XLamp® XP-G3 S Line Photo Red LED Product Change Notification

PCN Reference Number: PCN-06045

Date Issued: December 4, 2023

The following graph shows the improved Forward Voltage vs Current curve.

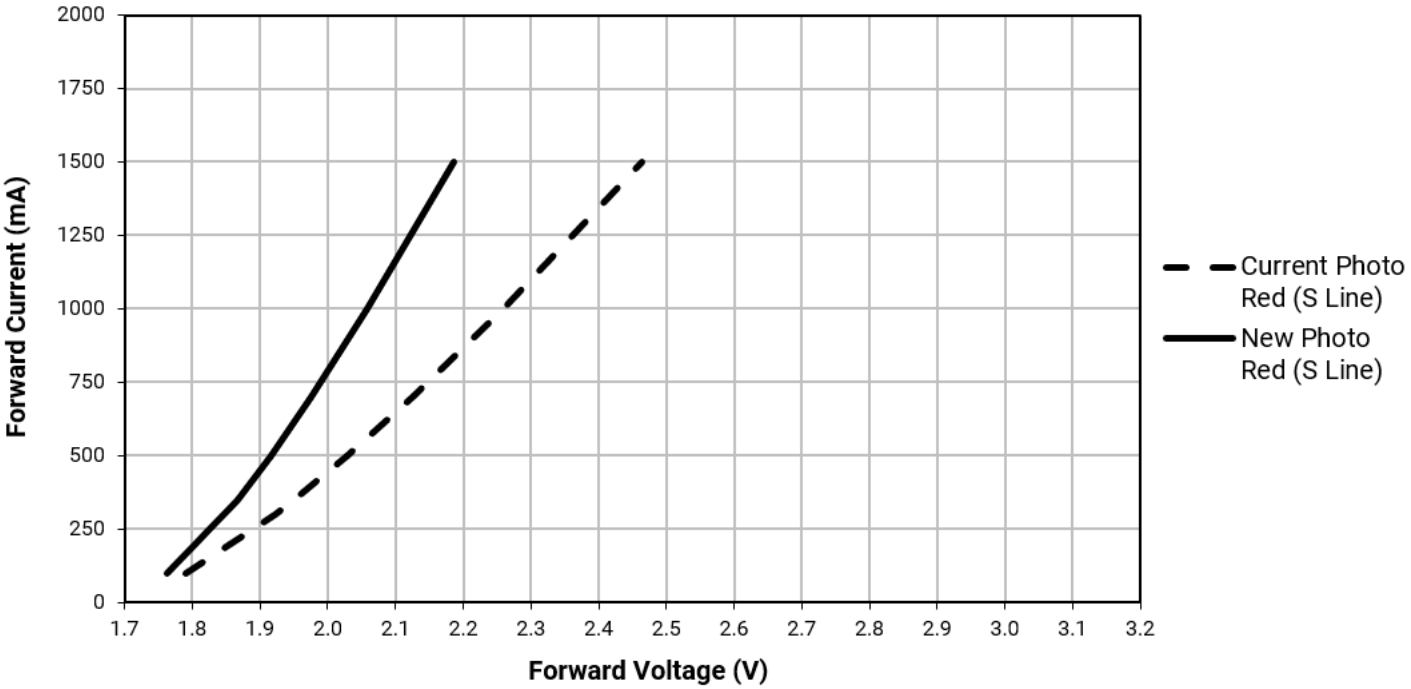
Cree LED will be changing the typical thermal resistance, typical forward voltage, and typical temperature coefficient of voltage characteristics for the affected XP-G3 LEDs. Table 2 shows the current and new values.

LED	Thermal Resistance, Junction to Solder Point (mV/°C)		Forward Voltage (V) @350 mA, 25 °C		Temperature Coefficient of Voltage (°C/W)	
	Current Typical	New Typical	Current Typical	New Typical	Current Typical	New Typical
XP-G3 S-Line Photo Red	1.0	1.2	1.95	1.87	-1.6	-0.9
